**PACIFIC AIR FORCES
REGIONAL SUPPORT CENTER**

**RECORD OF DECISION FOR
SITE OT008**

**FINAL
JULY 2017**

FIGURE NO:
1-1

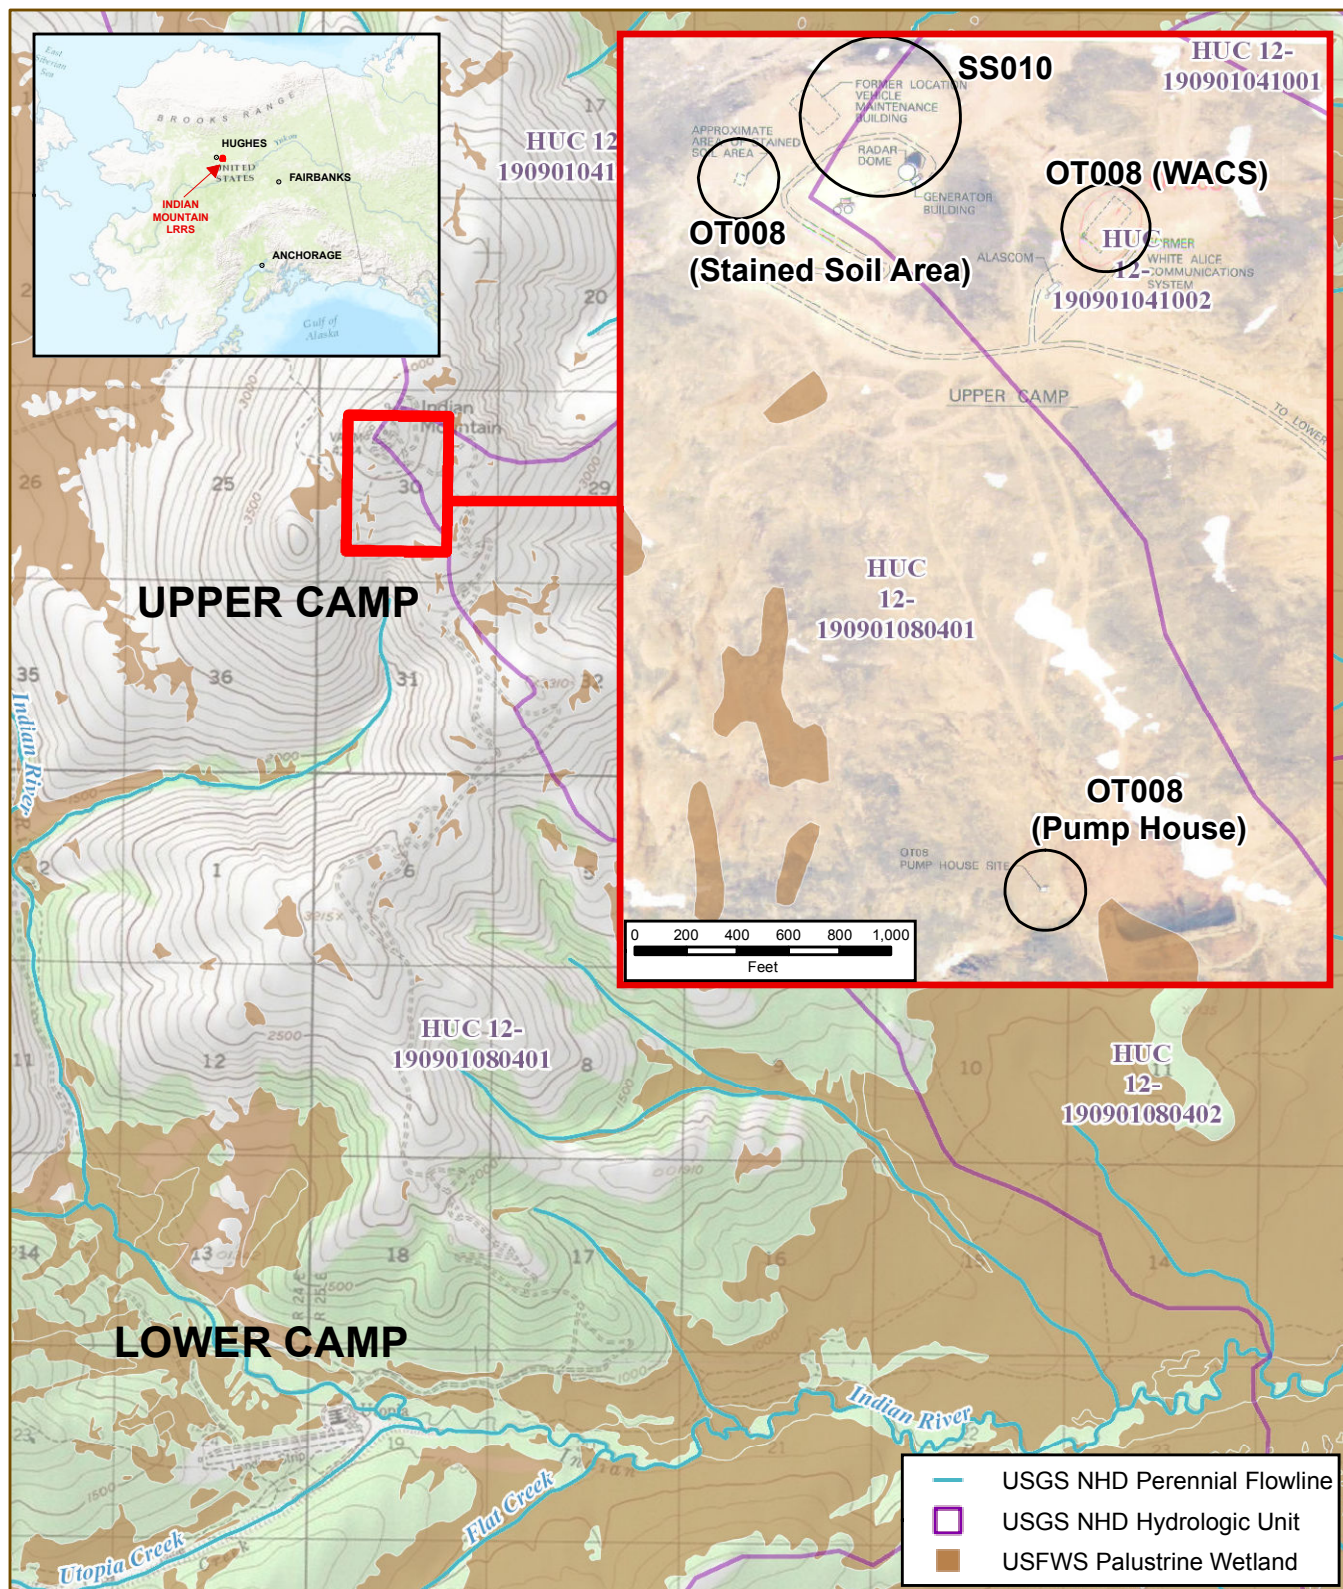
SUPPLEMENTAL COMMENT: Please include a figure of the drainage patterns with all waterbodies labeled for clarity.	Agree	Figure 1-1 for the entire Indian Mountain RRS will be revised with either the USGS or NGS service layers that indicate water bodies and drainage patterns, whichever is more detailed. Note that there is no continuous surface water at Upper Camp where OT008 is located.

OT008 WACS EXTENT OF CONTAMINATION
INDIAN MOUNTAIN LONG RANGE RADAR SITE
INDIAN MOUNTAIN, ALASKA

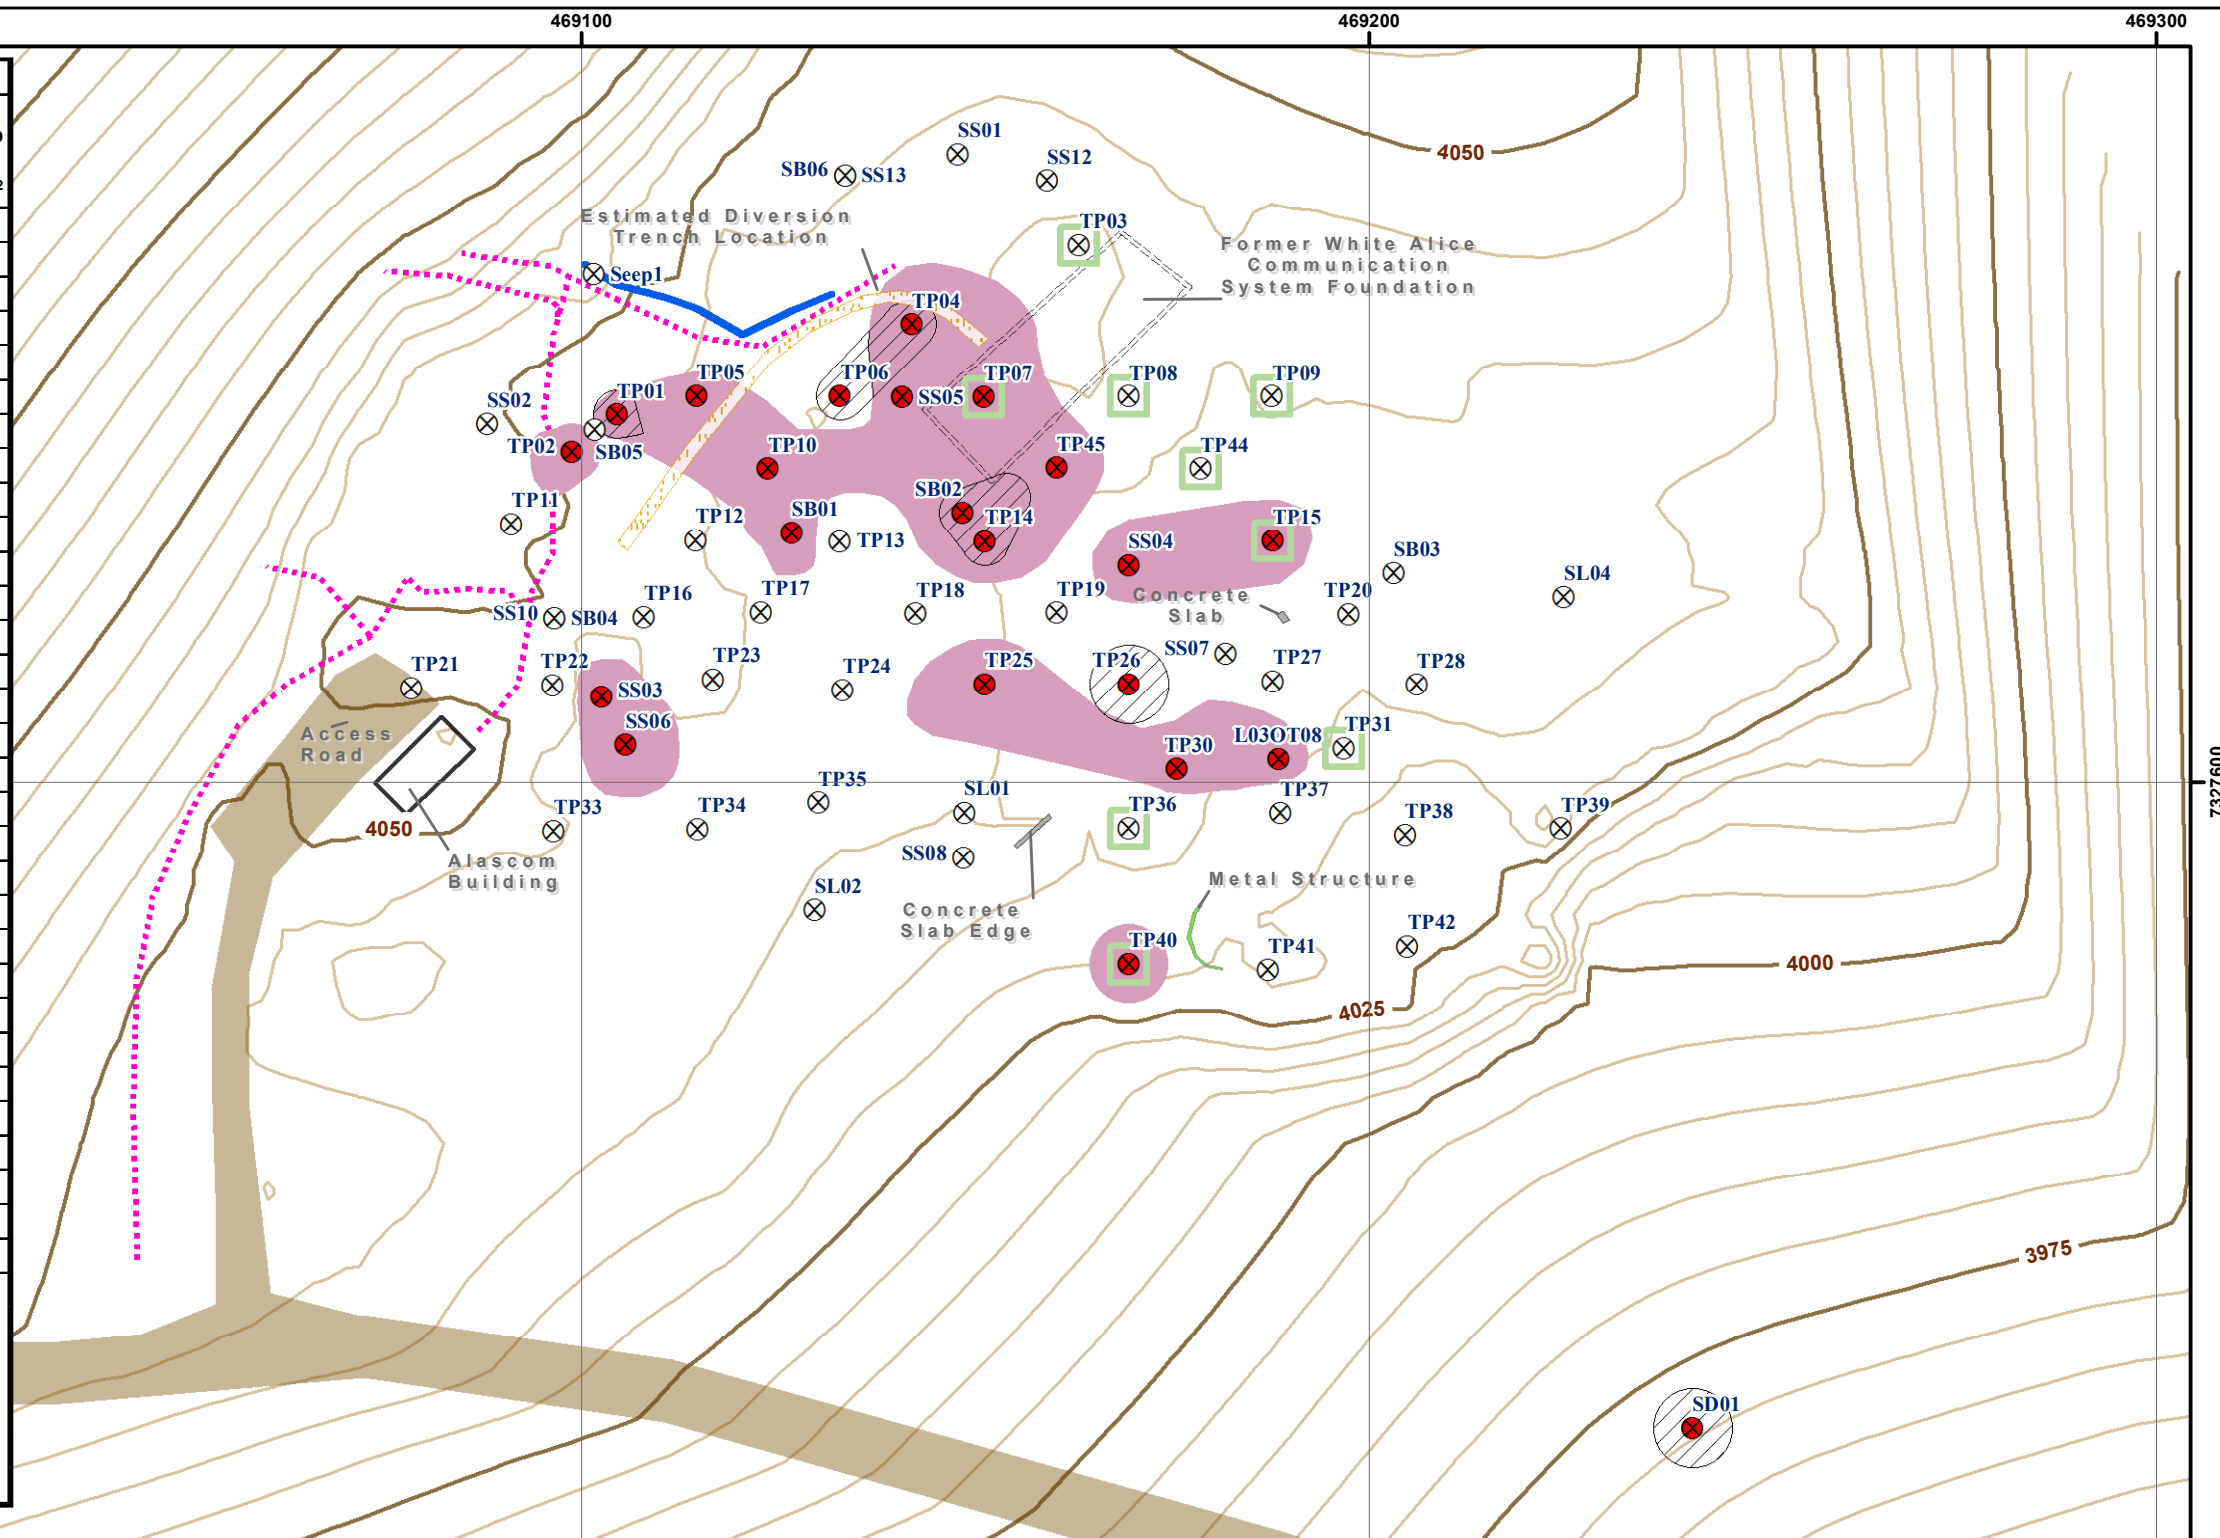
Cmt. No.	Pg. & Line	Sec.	Comment/Recommendation	Response
1.	1-7	1.4	The second paragraph states that GRO is present above cleanup levels at only one location (1,600 mg/kg at SD01), but the table on Figure 2-1 indicates that SB02 also exceeds cleanup levels at 7,700 mg/kg. Please include SB02 in this section.	Agree. The second to last sentence in paragraph 2, Section 1.4, will be revised: “Of these, only gasoline-range organics (GRO) is present above its cleanup level (1,400 mg/kg), and in only two locations: 1,600 mg/kg at SD01 and 7,700 mg/kg at SB02. For this reason, ...”

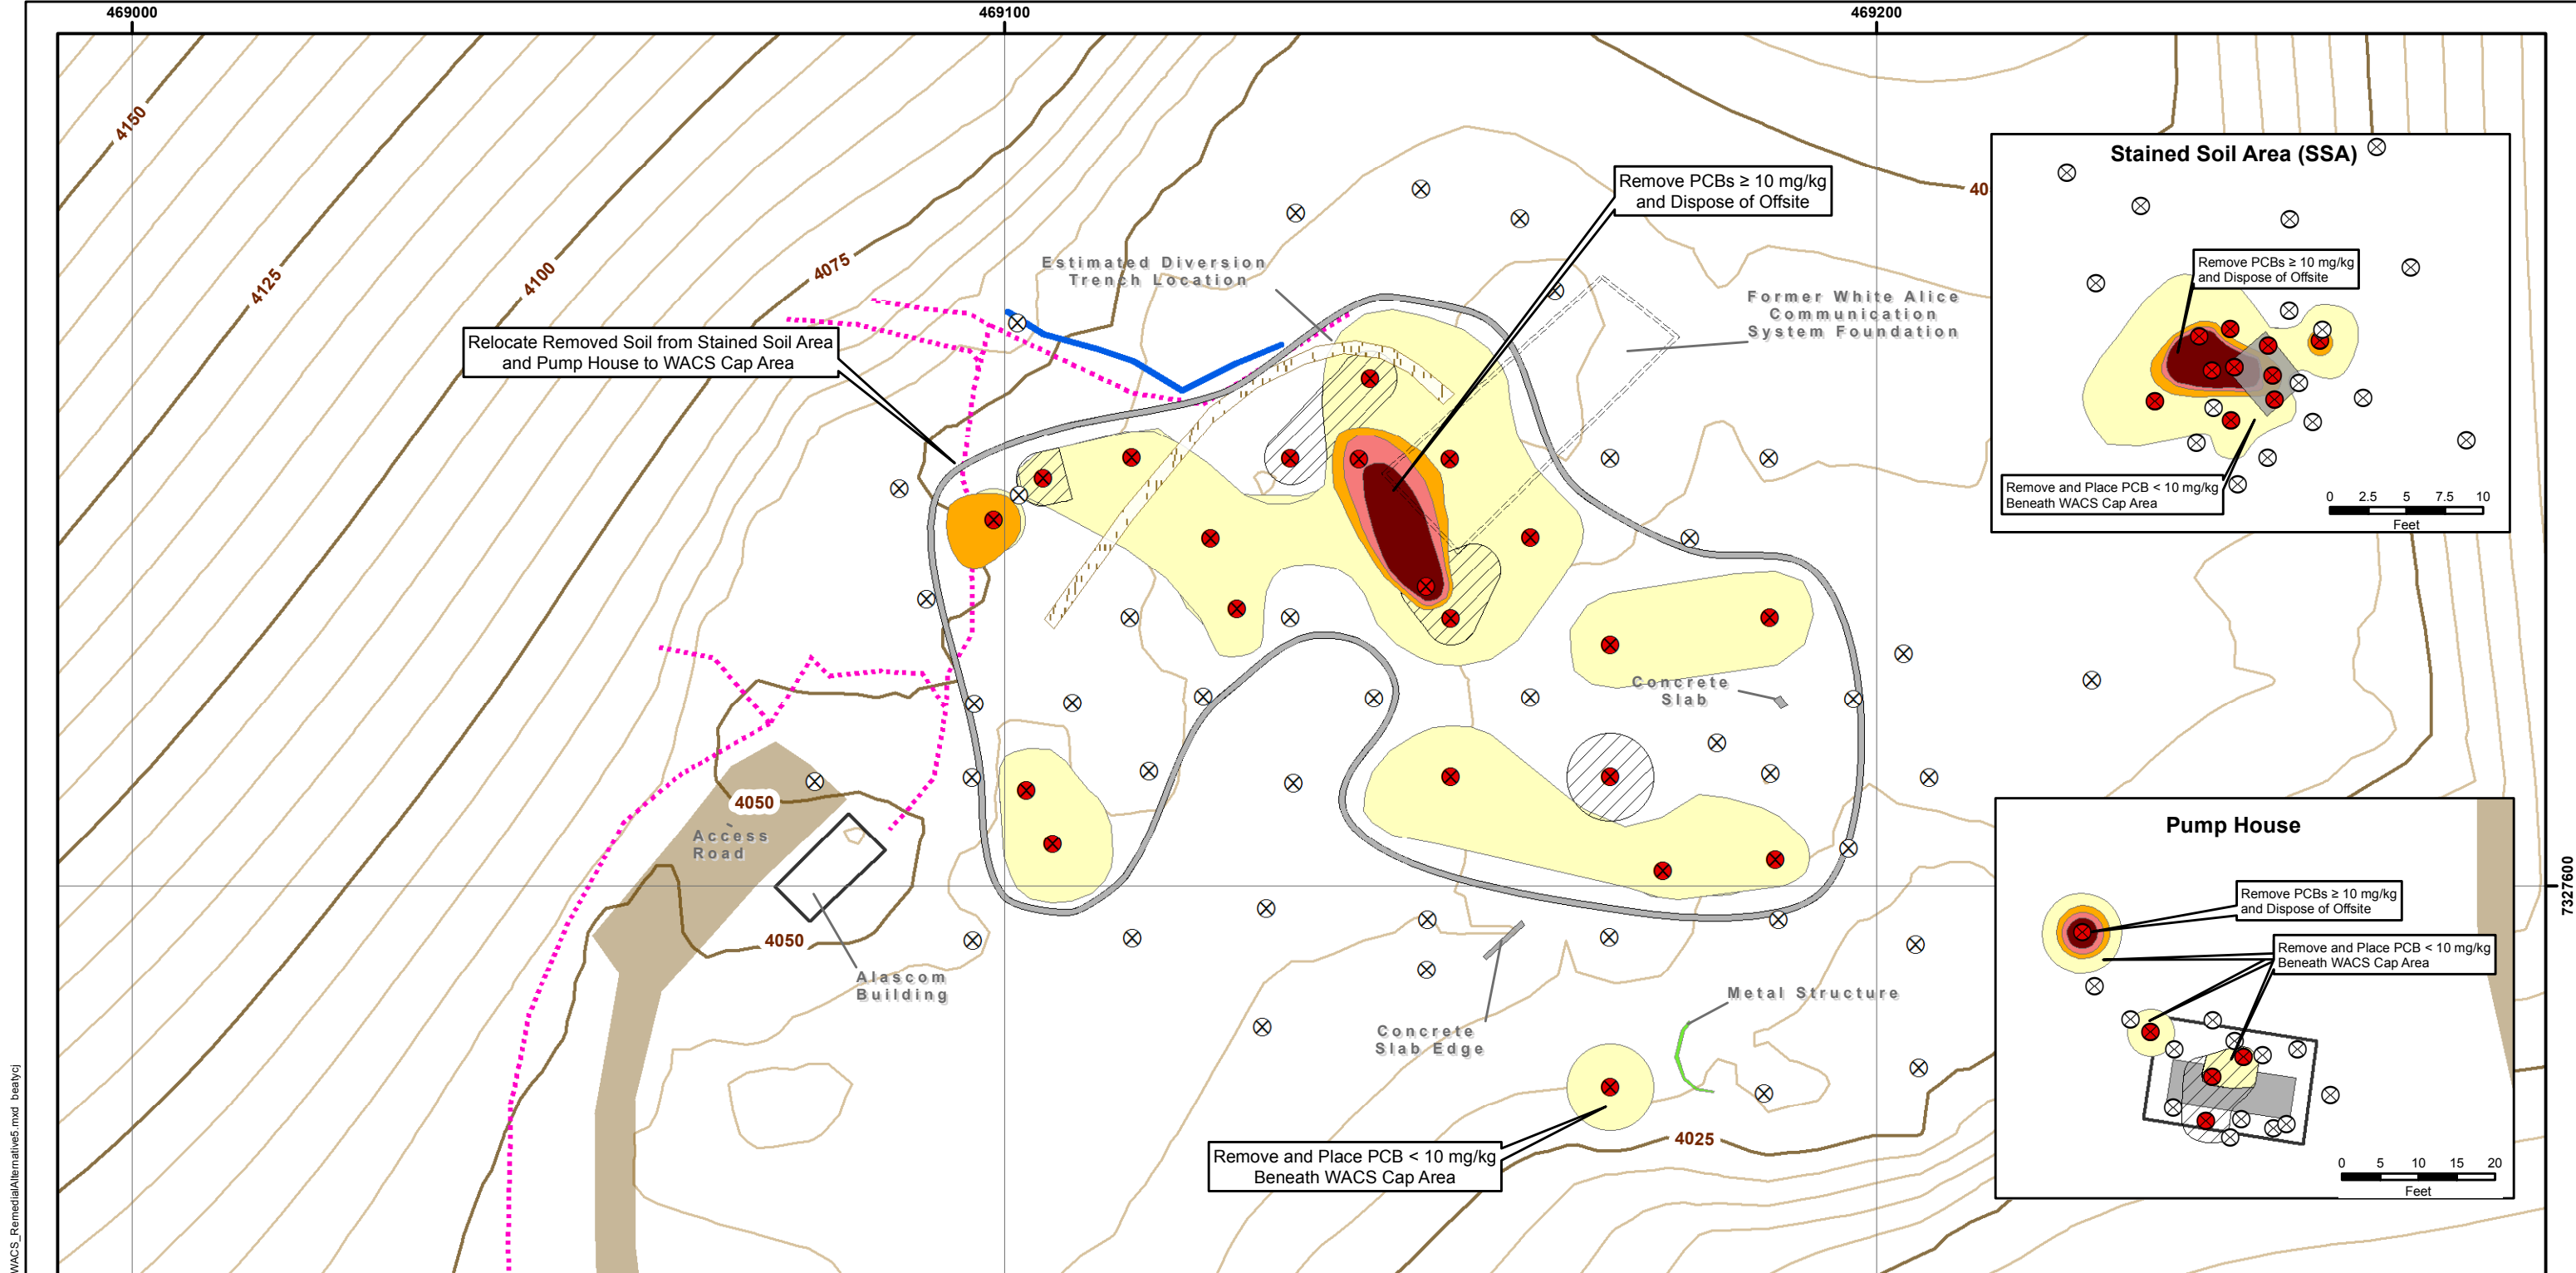
9.	2-61 and 2-63	2.12.2 and Figure 2-4	As previously discussed, ADEC recommends further consolidation of PCB contaminated soil to reduce the area covered by the cap and to make it more clear where the cap starts and stops. The large area and irregular shape	<p>Agree. USAF recommends discussing the recommended approach in an RI scoping meeting to ensure that the forthcoming work plan adequately addresses ADEC concerns while minimizing exposure risk to onsite workers.</p> <p>See also Response # 6; the permeable liner will serve as an indicator that cap</p>

8.	Page 2-43, Section 2.9.1	<p>a) Third Bullet: Upon review of this section and figure 2-4 I think we potentially have two different views of how this remedial action will be conducted in the WACS area. It appears the plan is simply to excavate the >10 ppm soil and then just cap the entire area. I was expecting to see some level of consolidation of the remaining PCB contaminated soil to reduce the extent of the area requiring capping. This will require confirmation sampling to ensure that all areas with PCB concentrations greater than 1 ppm have been removed and are placed in the capped area. I think the reduction of the capped areas will provide some saving to offset the cost of additional sampling and excavation.</p> <p>b) Fourth bullet. It appears the only requirement for the cap is that it be a minimum of 2-ft of clean fill. The cap should be constructed to resist wind and water erosion and should include a crushed rock cover and other features to ensure durability over time. Recommend stating that the cap will be designed to reduce erosion.</p> <p>c) Sixth bullet. Annual reviews and documentation of maintenance should be provided to ADEC in a timely manner. Not just presented in the Five year</p>	a) Unclear	<p>a) Page 2-43 addresses PCB Alternative 4, which is the onsite monofill option. Figure 2-4 shows PCB Alternative 5, which explicitly states that soils from the Pump House and SSA will be placed under the WACS cap and is consistent with the remedy description.</p> <p>If the comments refer to PCB Alternative 5 on Page 2-44, bullet 1 addresses consolidation and capping at the WACS:</p> <p>"PCB-contaminated soil from 1 mg/kg to less than 10 mg/kg will be removed from the Stained Soil Area and Pump House for consolidation and capping at the WACS."</p> <p>Bullet 3 addresses confirmation sampling:</p> <p>"Confirmation soil samples will be collected from the excavations to show that remaining PCB concentrations are below the cleanup level (1 mg/kg) at the Stained Soil Area and the Pump House, and below 10 mg/kg at the lateral and vertical extents of the WACS excavation."</p> <p>The alternative will be re-titled: "Offsite Disposal of PCB-Contaminated Soil 10 mg/kg and Above, and Onsite Consolidation and Capping of PCB-Contaminated Soil From 1 mg/kg to Less Than 10 mg/kg."</p>	Agree
